Department of Water Resources

Date: December 31, 2019

Subject: Response to expert report in the matter of designating the Eastern Snake Plain Aquifer Ground Water Management Area, Docket No. AA-GWMA-2016-001

Figure 1. Location of the Rexburg Bench, ESPA area of common ground water supply, and ESPAM2.1 model boundary

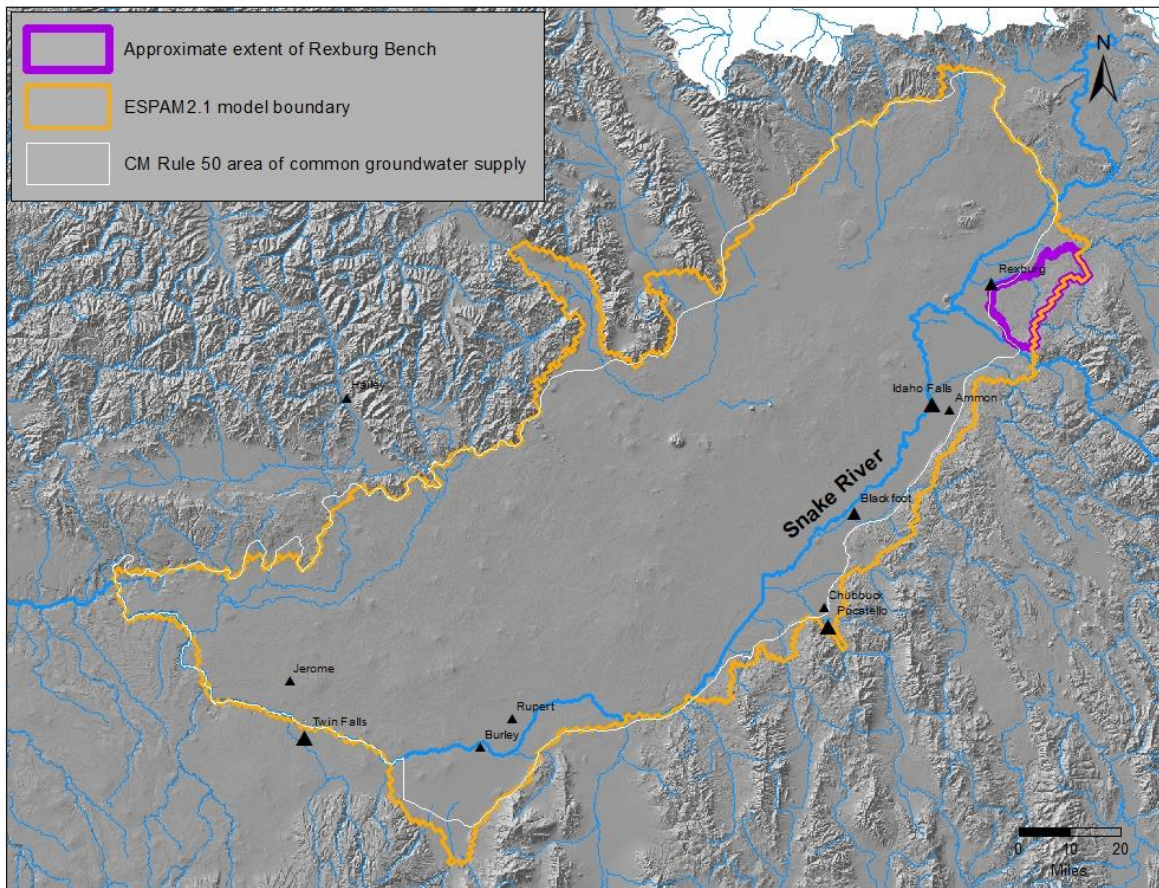
Contor's discussion of this issue is limited to one specific area, commonly referred to as the Rexburg Bench. The locations of the ESPA area of common ground water supply, the Eastern Snake Plain Aquifer Model Version 2.1 (ESPAM2.1) boundary², and the approximate location of the Rexburg Bench are shown in Figure 1. Contor does not explicitly delineate the boundaries of

the Rexburg Bench. For this memorandum, the extent of the Rexburg Bench delineated by Haskett (1972) was used in conjunction with the ESPA area of common ground water supply and ESPAM2.1 boundaries to identify the approximate extent of the Rexburg Bench.

Figure 2. Location of rivers and other features mentioned by Haskett

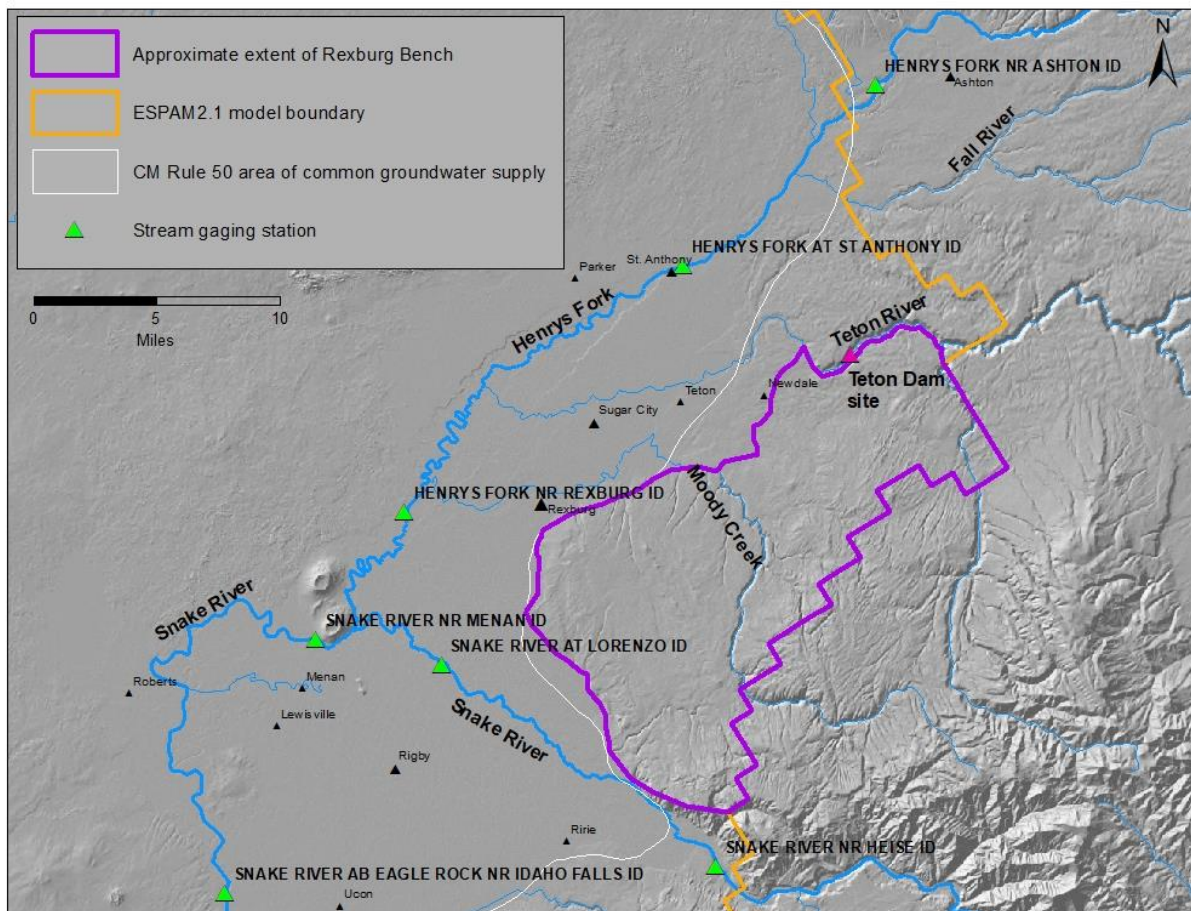
Haskett stated that in the early 1960s, there were concerns that groundwater development for irrigation on the Rexburg Bench would be limited by locally available recharge, but that by 1970, groundwater development had already exceeded expectations without indications of excessive water level declines. This suggests the Rexburg Bench has a strong hydrogeological connection to the regional Eastern Snake Plain aquifer system. Haskett discusses three possible sources of inflow to the Rexburg Bench from the regional Eastern Snake Plain aquifer system. For reference, Figure 2 shows rivers and other features mentioned by Haskett, and Attachment A provides a copy of Haskett’s water table contour map.

“At the extreme north end of the Bench, in the vicinity of Newdale, some water lost from the Teton River reaches the regional water body. Gaging data by the USBR show that the Teton River has no loss in 8- or 10- mile reach above the damsite, but loses up to 50 cfs in the 5-mile reach downstream. The local gradient shows that some of this inflow may reach a few of the northernmost wells.

A second possibility is suggested by the anomalous north and northwest directed gradient. Much of the flow of the regional water under the Rexburg Bench is from the south and southeast. It would appear that a reach of the Snake River in the vicinity of Heise loses water to the valley alluvium which is in contact with basalts and rhyolite extending under the Bench.

A third possible source is from the alluvium of the Henrys Fork Valley. During the pumping season on the Bench[,] the water table is locally pulled down 6 to 12 feet effecting a potential gradient reversal along the west margin of the Bench. This could allow great quantities of water to move eastward from the saturated alluvium of the Henrys Fork Valley to Rexburg Bench aquifers.”

Figure 3. Diversion rate per well for licensed and decreed groundwater rights developed for irrigation use

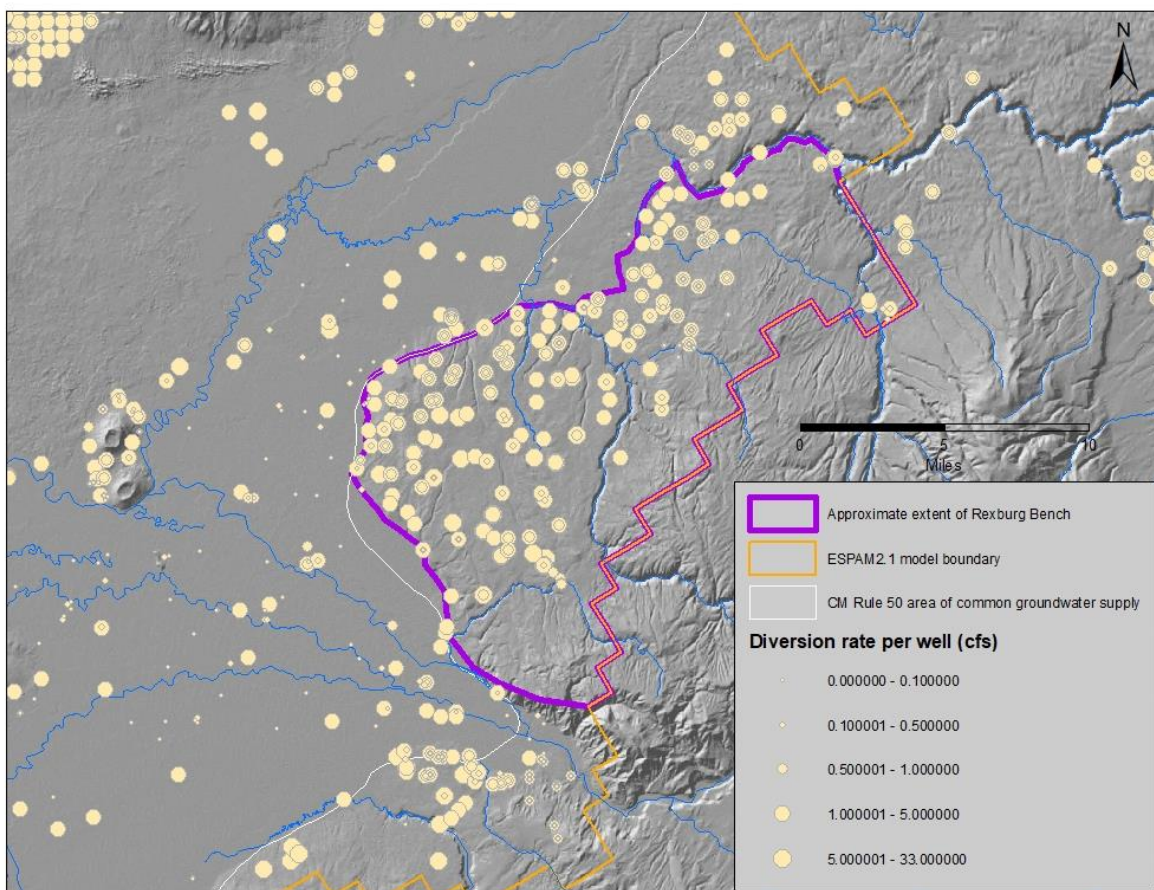
Considerable groundwater development has occurred on the Rexburg Bench since Haskett's study. Records of groundwater rights developed for irrigation use on the Rexburg Bench show that groundwater development for irrigation has almost doubled since the end of the 1970 irrigation season. On the Rexburg Bench, licensed and decreed water rights developed solely for irrigation with priority dates of 1970 or earlier have a total authorized diversion rate of approximately 418 cfs, while those with priority dates of 1971 or later have a total authorized diversion rate of approximately 384 cfs. Groundwater irrigation water rights on the Rexburg Bench have a mean authorized diversion rate per well of approximately 540 gpm and a maximum authorized diversion rate per well of 3,870 gpm. These values are consistent with the well yields reported by Haskett and support the conclusion that groundwater beneath the Rexburg Bench has a strong hydrogeological connection with the regional Eastern Snake Plain aquifer system. While not all of the geologic materials beneath the Rexburg Bench have high permeability, substantial portions of the basalt and rhyolite rocks have very high permeability, and the highly permeable deposits are well-connected with each other and with highly permeable sediment and basalt deposits outside of the Rexburg Bench. The distribution of groundwater development in the Rexburg Bench area is shown in Figure 3.

Figure 4. Water level elevations measured during the spring of 2013

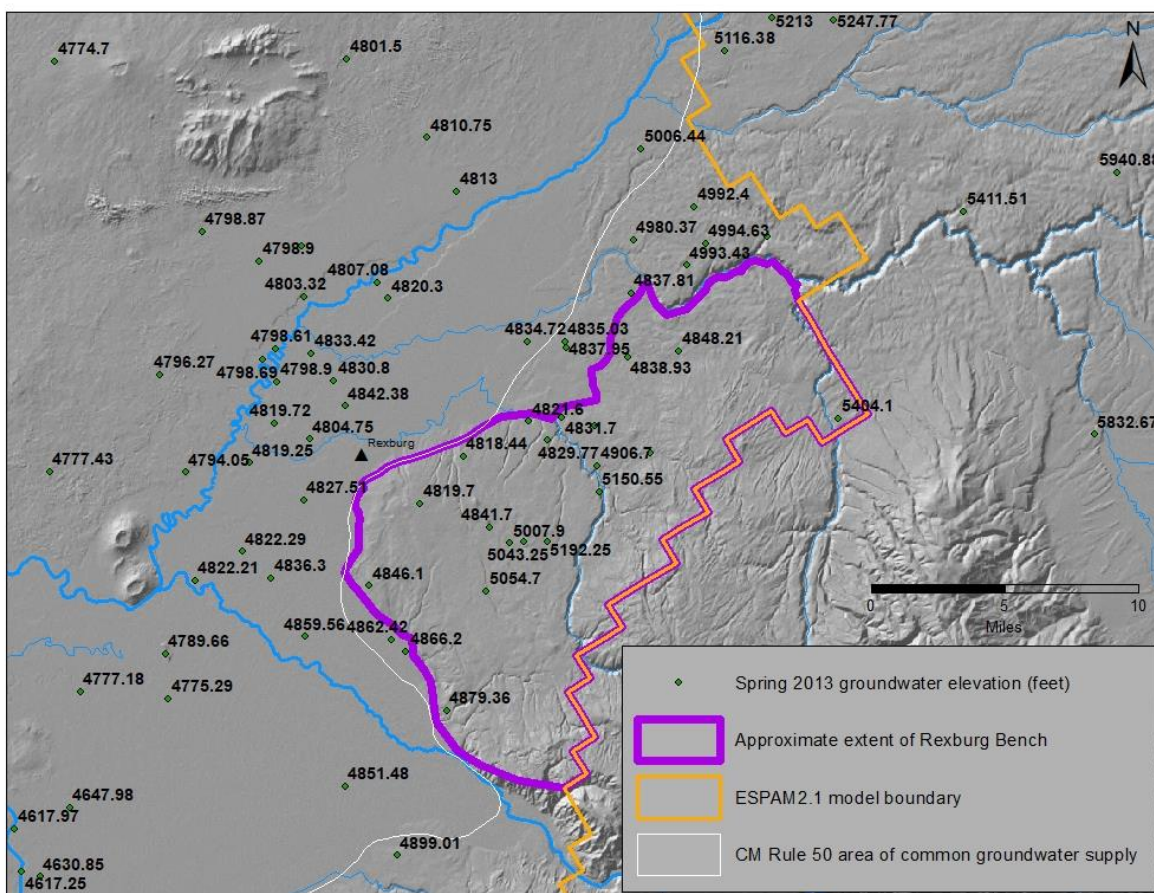
More recent water level measurements are generally consistent with water level information presented by Haskett and do not suggest the Rexburg Bench is hydrogeologically disconnected from the ESPA. Water level elevations measured during the spring of 2013 on the Rexburg Bench and the Snake River Plain are shown in Figure 4. Within the Rexburg Bench, water level elevations are highest in wells closest to the Big Hole Mountains and generally decrease towards the outer margins of the Rexburg Bench. Local groundwater gradients vary in steepness and direction because of the locations of recharge sources and the geometry of the Big Hole Mountain front relative to the Henrys Fork and Snake River valleys. There is not a sharp transition or steep gradient between water level elevations near the edge of the Rexburg Bench and water level elevations in the adjacent Henrys Fork and Snake River valleys, which indicates there is not a geologic feature significantly impeding groundwater flow between the Rexburg Bench and the Snake River Plain. This is consistent with Haskett's characterization of the connection between

groundwater in the alluvium of Henrys Fork and Snake River valleys and groundwater underlying the Rexburg Bench, which was discussed in the previous section of this memorandum.

Figure 5. Delineation of Eastern Snake River Plain and Snake River Basin in RASA study (from Garabedian, 1992)

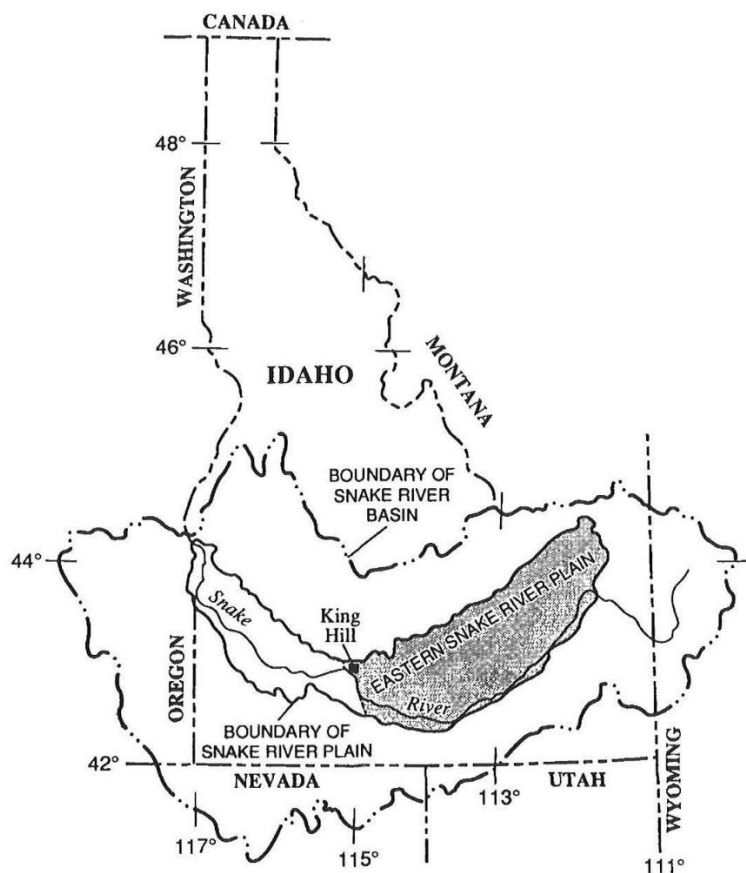
The RASA boundary is the basis for the area of common ground water supply boundary in the vicinity of the Rexburg Bench. The RASA boundary delineated in Garabedian (1992) and other reports in the RASA series is referred to as the “boundary of Eastern Snake River Plain” and is not referred to as a “basin” boundary. Multiple figures in these reports show the delineation of the Eastern Snake River Plain boundary within the larger Snake River Basin boundary, Figure 5 is an example from Garabedian (1992).

Figure 6. Example from Garabedian (1992) showing impact of changes in underflow from tributary drainage basins (including the Rexburg Bench) on aquifer head within the RASA boundary.

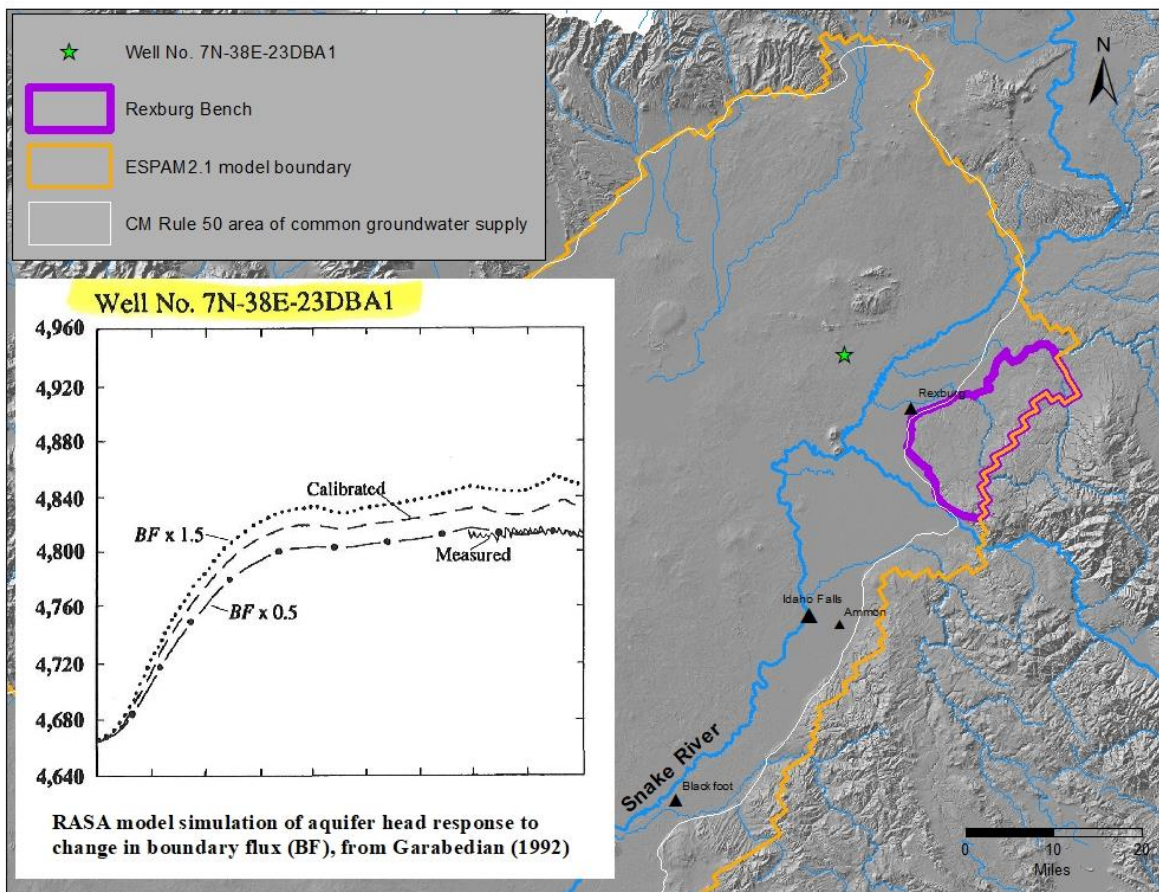
Garabedian (1992) used the RASA model to simulate the effect of changes in boundary flux (underflow from tributary drainage basins) on aquifer heads and aquifer discharge to the Snake River. For example, Figure 6 shows the predicted head response at a well located approximately 10 miles from the Rexburg Bench resulting from a 50% increase or a 50% decrease in boundary flux. Change in consumptive use of groundwater for irrigation within a tributary drainage basin is one example of a change in boundary flux. Garabedian's simulations illustrate that changes in consumptive use of water outside of the RASA boundary affect aquifer heads within the RASA boundary.

Figure 7. Groundwater points of diversion developed for irrigation use in the ESPAM2.1 model domain and tributary drainage areas within the Snake River basin

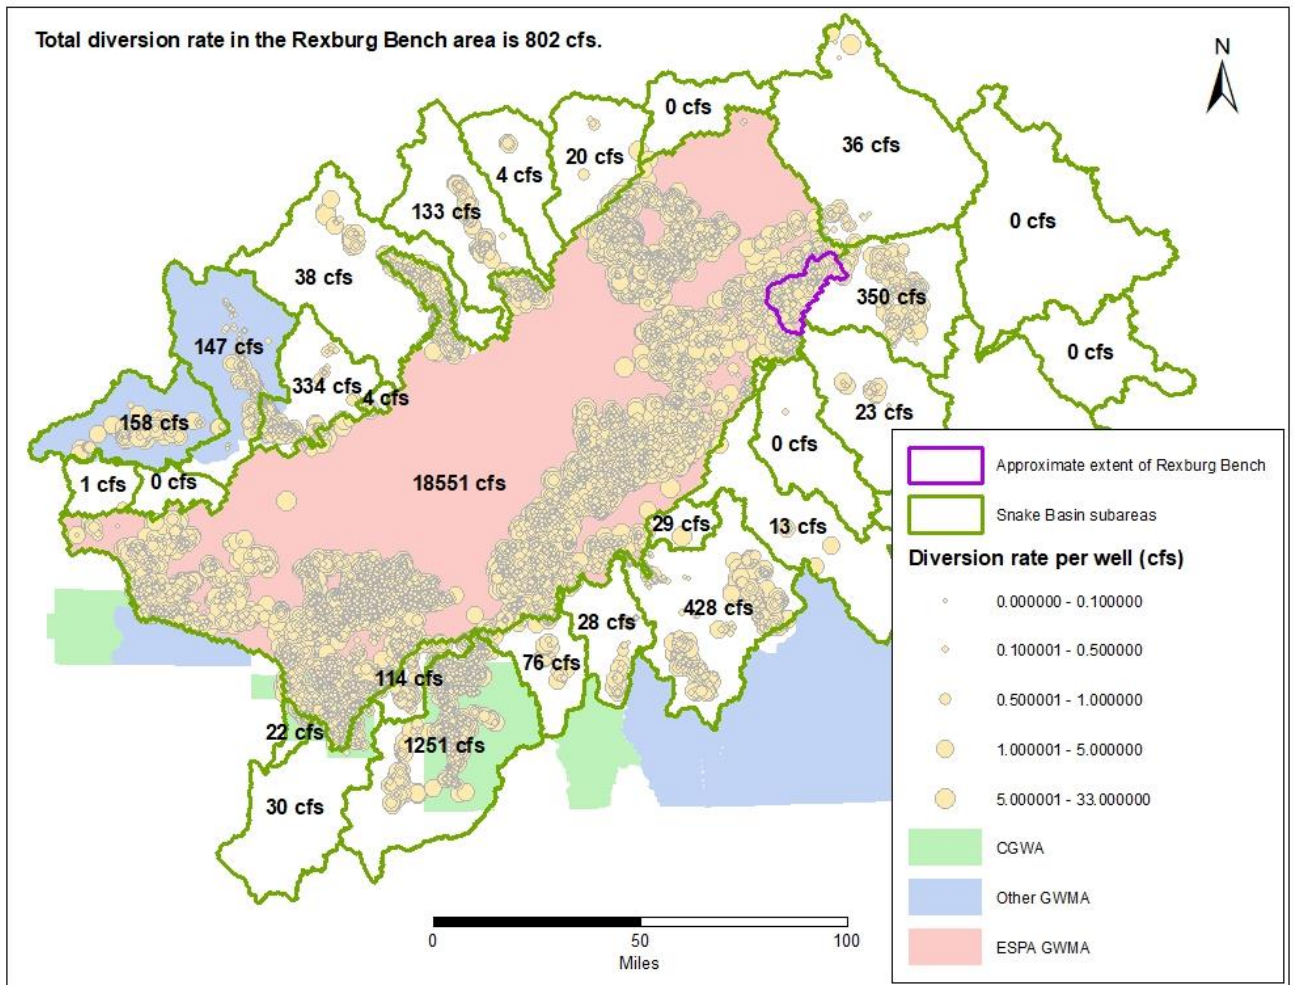
Figure 7 shows groundwater development for irrigation within the ESPAM2.1 model domain and within tributary valleys outside of the model domain. Groundwater development was quantified by summing authorized water right diversion rates of licensed and decreed water rights developed solely for irrigation use. By this measure, groundwater development in the Rexburg Bench is approximately 4% of the total groundwater development within the model domain. The only area outside the model boundary with more groundwater development than the Rexburg Bench is the Raft River drainage area, and the majority of this area is already designated as a Critical Ground Water Area (CGWA). Other areas identified by Contor as being “*less or similarly distinct from the ESPA than is the Rexburg Bench*” have considerably less groundwater development than the Rexburg Bench.

As discussed previously, the ESPAM2.1 is not a basin-wide model and groundwater use in tributary areas does affect groundwater and/or surface water inflow to the Eastern Snake Plain. From a technical standpoint, consumptive water use in all of the excluded areas identified by Contor has an effect on groundwater and surface water availability within the Snake River Plain. This issue was acknowledged and discussed in Findings of Fact 13 through 17 in the order designating the GWMA. Conclusions of law 17 through 21 acknowledge that the GWMA designation only includes part of the groundwater basin and explain the reasoning for the delineation of the GWMA boundary.
